# PRODUCT ADVISORY

**Products:** CHM/CHCC Series Modular Fuse Holders

**Number:** PA-PP-007

**Subject:** Design Changes to CHM/CHCC Series Modular Fuse Holders

## New Design Fuse Holders

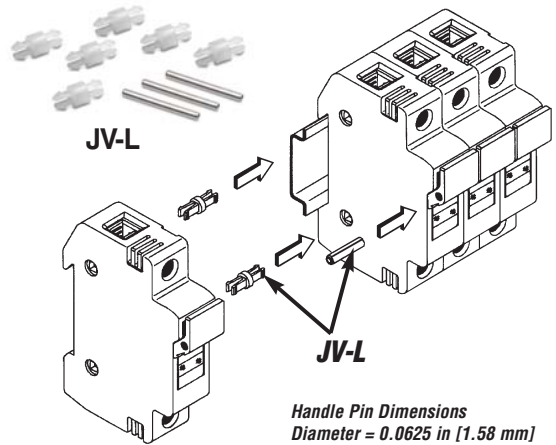
Notice that the shape is slightly different and the Neon indicators are now smaller and circular.

## Retired Design Fuse Holder Dimensions,

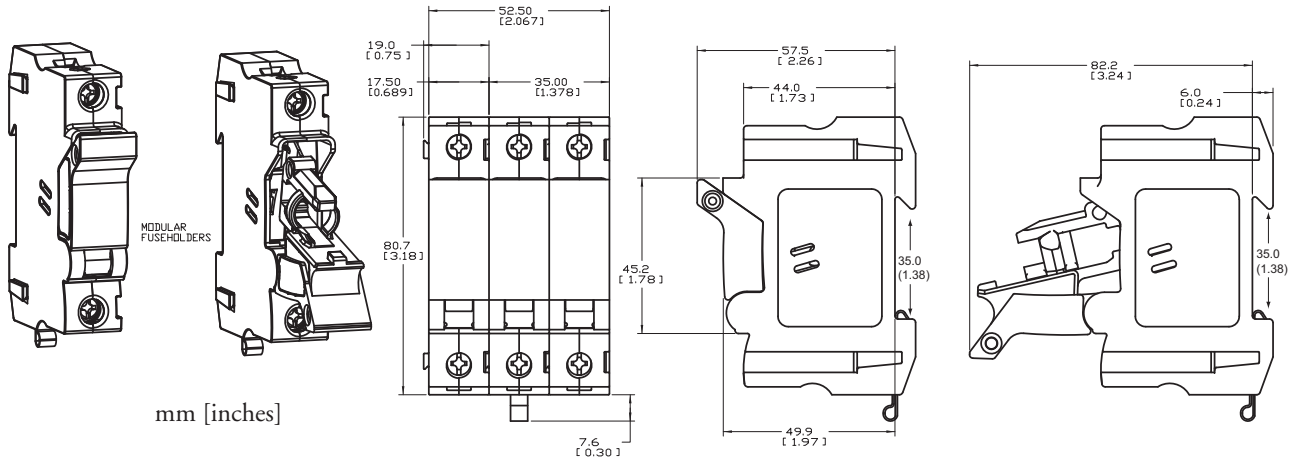
- Overall height reduction from 3.071 inches to 2.83 inches to reduce space needed in OEM panels.
- The NEON indicator on the holders has changed from rectangular to circular on the front of the holder, if equipped.
- See the dimensional drawings on the following pages for more details on the changes between versions.
